Waterbeach Bridleways Group Comment on:

Mere Way Byway 21/04625/FUL (including A10 bridge 21/04353/REM and A10 Slap Up Junction safety upgrade) (S106 requirements of developers of Waterbeach Newtown, Urban and Civic)

8th November 2021

Currently Accessible Multi-Use Paths

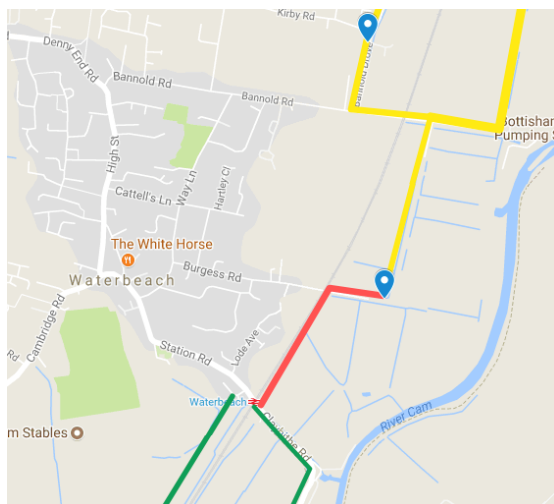
The yellow paths are Long Drove, Burgess Drove, Bannold Drove, and Cross Drove. These paths are currently accessible to equestrians, as well as vehicles (car and farm), bicycles, and pedestrians. All are single vehicle in width, and in most places are bordered on both sides by ditches. Although wide enough as a bridleway already, the addition of places to step off the droves and/or a parallel path would support increased cycle, pedestrian, and equestrian usage.
